AMERICAN SUZUKI MOTOR CORPORATION

DEFECT INVESTIGATION

**RE: Recall Campaign for VZ800, VL800/T/Z K5/6 Ignition Switch**

**SAFETY RECALL CAMPAIGN**  
ALL 2005 AND CERTAIN 2006 VL800/T/Z BOULEVARD C50/T  
& VZ800 BOULEVARD M50 MOTORCYCLES  
IGNITION SWITCH INSPECTION/REPLACEMENT

### 4. Check and reroute the lead wire

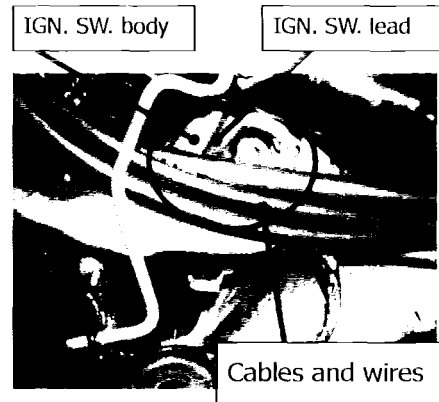
If the ignition switch lead wire is pinched in between ignition switch body and cables, remove throttle cable guide and reroute the lead wire. Ignition switch lead wire and coupler should be located underneath the switch body, see below picture.

If ignition switch lead wire is already damaged, replace the ignition switch as LOCK SET which consists of ignition switch, fuel tank cap, side cover lock and helmet lock, referring service manual.

**REPAIR PROCEDURE:**

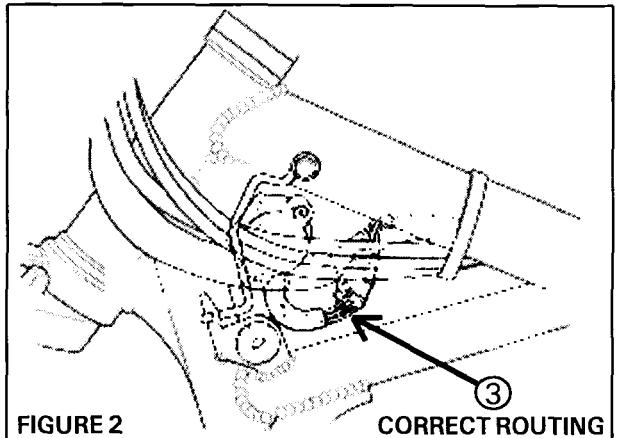
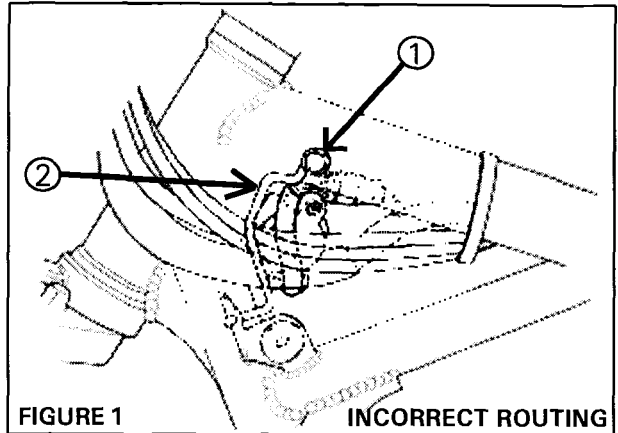
3. Remove ignition key and right side frame head cover. Remove left side frame head cover.
4. Inspect the ignition switch wiring harness ③ routing. If correct, re-install the frame head covers, fuel tank and front and rear seats. Proceed to Step 7.
5. If routing is incorrect, remove guide bolt ① and guide ② only. Inspect and re-route wires as shown in Figure 2.

If the protective covering over the ignition switch sub-harness is cut and the insulation of the lead wires is cut and/or abraded, replace the ignition switch and lock set. (Refer to VL800 Service Manual page 8-29 and VZ800 Service Manual page 9-35 for ignition switch replacement).

If the wire insulation is not cut and only the outer protective covering is damaged/cut, wrap the sub-harness with several wraps of electrical tape. In addition, if the clutch cable/throttle cable is damaged replace as necessary.
